Fourth session of the IG CMS-II in the “Palais des Nation” in Geneva

29.-30.09.2014

Aspects covered:

- Point light sources
- Grey scale rendering
- Color noise
- Gloss of monitor housing

Proposed requirement – Alternative 2:

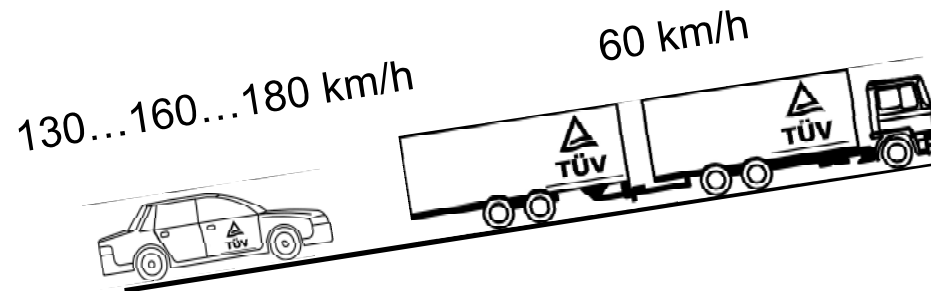
For safety reasons point light sources (e.g. low beam headlights) shall be rendered as point light sources and be distinguishable.

Two point light sources having a luminance of $x \text{ cd/m}^2$ [tbd] and which are separated by 1 m [tbd] at a distance of 250 m [tbd] away from the camera shall be distinguishable, when tested according to Annex x [tbd].

The distance of 250 m is based on a velocity difference of 70...120 km/h between two vehicles.

Physiological process (perceiving – detection – analysing – judgement – decision) for:
young people $\approx 3 \text{ s}$
older people $\approx 7 \text{ s}$

Grey scale rendering – 1

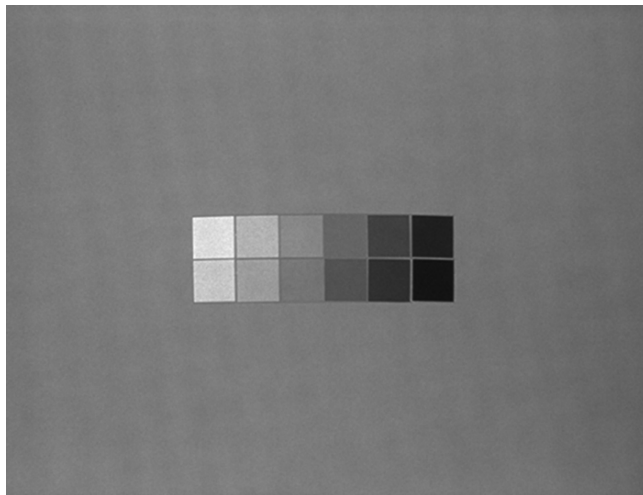
Grey scale rendering prevents from losing information, e.g. traffic sign, PLS, which is a safety aspect.

with grey scale rendering

without grey scale rendering (black – white)

A mirror renders object luminances according to its reflectance – there is no loss of grey scale.
